ET 07-0050

Subject: Docket No. 50-482: Response to Request for Additional Information Relating to Replacement of the Main Steam and Feedwater Isolation Valves and Controls

RESPONSE TO NRC REQUEST FOR ADDITIONAL INFORMATION (August 20, 2007)

Response to NRC Request for Additional Information on the Wolf Creek Small Break LOCA Analysis

Figure 1: Suction Leg Liquid Level (3 inch break)

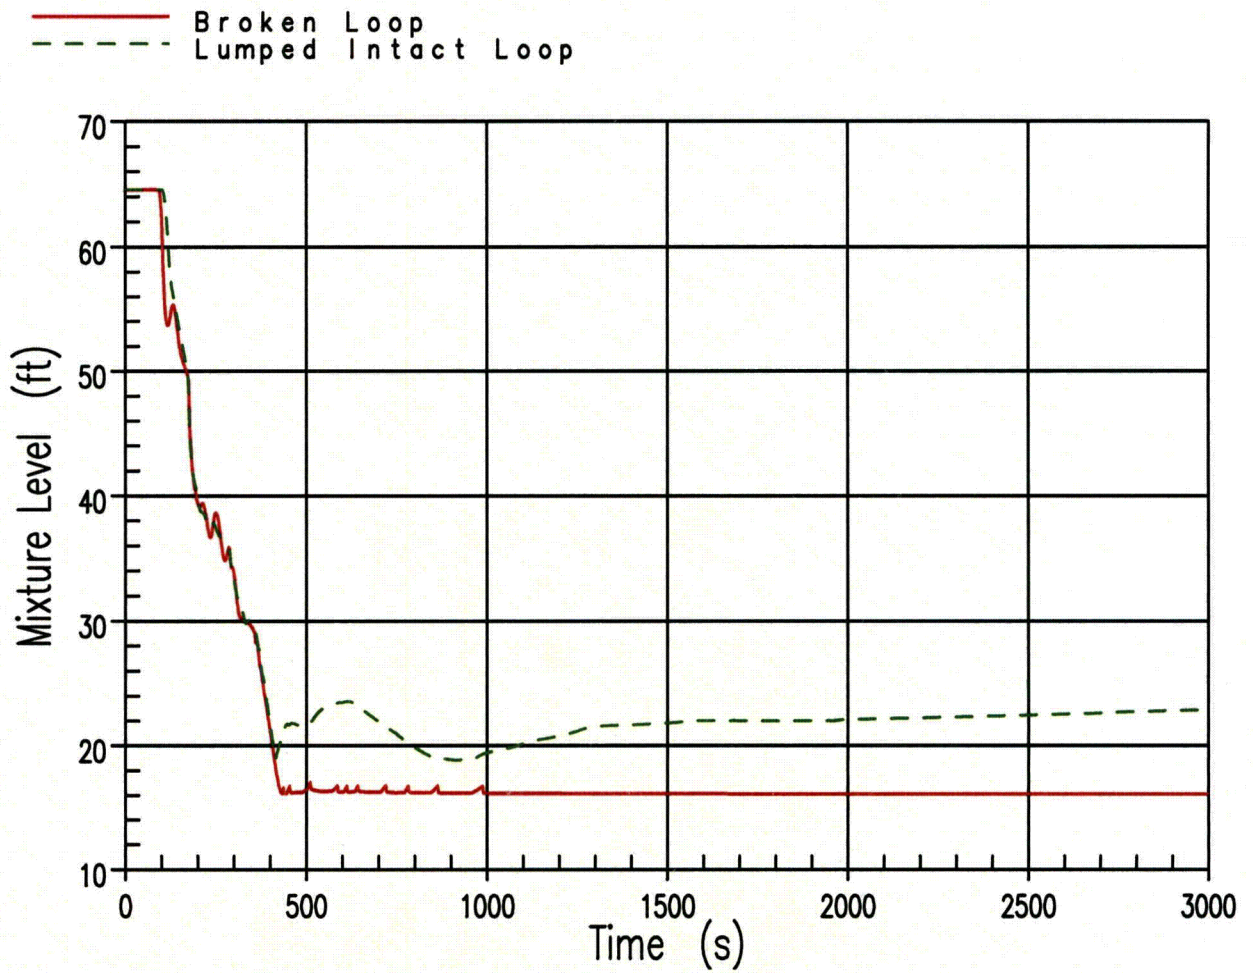
16. *Identify the number of loop seals that are cleared for the 3, 4, and 6 inch break sizes listed in Table 4.6-5, and provide the suction leg liquid level plots for these cases.*

Only one loop seal clears for the 3 and 4 inch breaks. This is due to the artificially imposed restriction in the NOTRUMP Evaluation Model to restrict steam flow through the lumped intact loop as to ensure that venting steam flow through the loop seal of the broken loop will occur first. Justifications for its conservative effect on calculations are described further in References 2 and 3.

Both the broken and lumped intact loop loop seals clear in the 6 inch break (note that loop seal clearing in the lumped intact loop represents that all 3 intact loop loop seals have cleared). For this break, the artificial restriction was removed since six inch and larger breaks typically have sufficient steam flow to vent through all loops for an extended period of time. The removal of this restriction is only acceptable if the broken loop loop seal clears prior to the lumped loop. In this case, the broken loop loop seal clears at 55 seconds into the transient and the lumped intact loop seal clears seconds afterwards.

The suction leg liquid level plots for both the broken loop and lumped intact loop are provided below in Figures 1 through 3 for the 3, 4, and 6 inch breaks respectively.

**Figure 4: Core Mixture Level (3 inch break)**

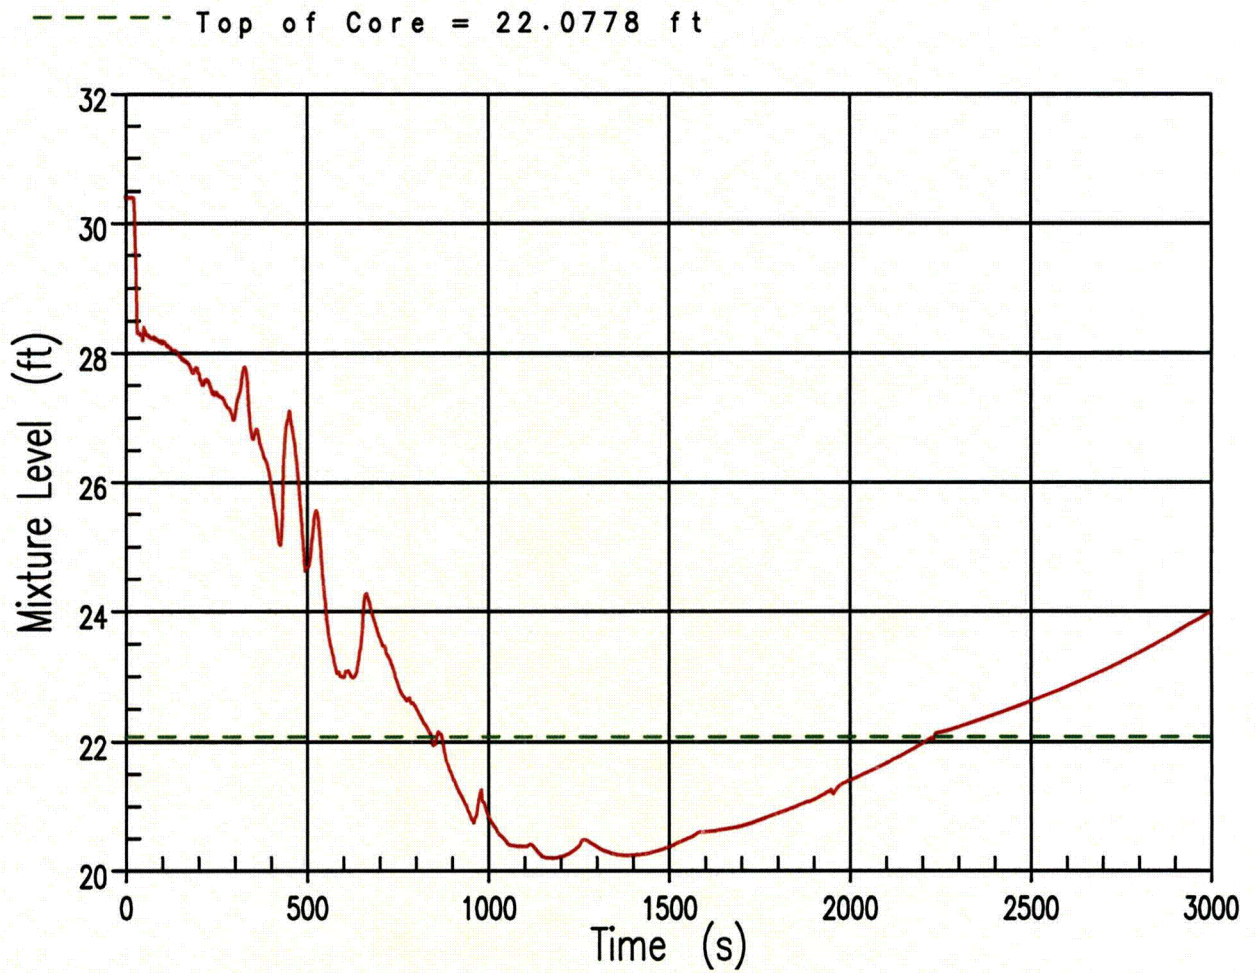
17. *Figure 4.6-2, page 65 of 133 in Attachment I, on the core mixture level is presented for the 4-inch break. Provide the core mixture level plots for the 3 and 6 inch breaks in the spectrum, where it is stated, on page 59 of 133 in Attachment I, that SBLOCTA code calculations were also performed.*

The core mixture level plots for the 3 and 6 inch breaks are shown below in Figures 4 and 5 respectively.
